Report No. 10CFR21-0123
Rev. 0: 11/30/18

**10CFR21 REPORTING OF DEFECTS
AND NON-COMPLIANCE**

COMPONENT: EMD fuel and soakback pumps – potentially undertorqued cover bolts

SYSTEM: Emergency Diesel Generator

Figure 1: Exploded View of Pump P/N 8410219

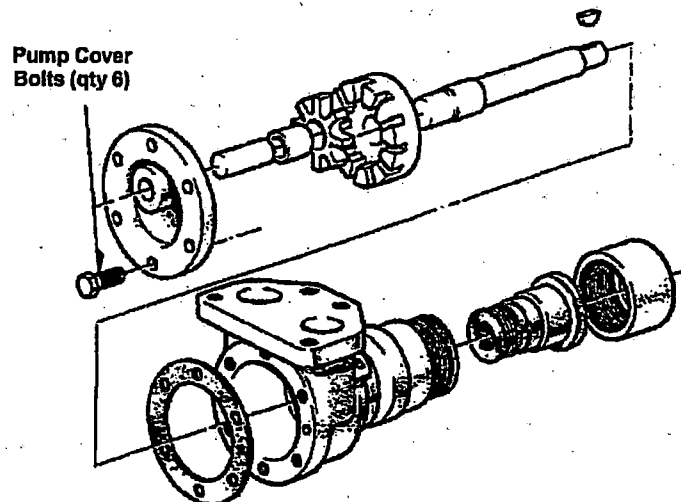
ESI was notified by a nuclear customer of two instances where a bolt was found loose or backed out of the cover of an EMD engine driven fuel pump P/N 8410219. Following notification, ESI inspected remaining pumps in inventory and found instances where one or more the pump cover bolts were loose or lightly torqued. See Figure 1 below for a visual depiction of the pump and bolts.

ESI recommends inspecting the bolts of all pumps for proper bolt tightness. Use a torque wrench and ensure all bolts are tightened to 108 to 120 in-lbs (12 to 13 Nm).
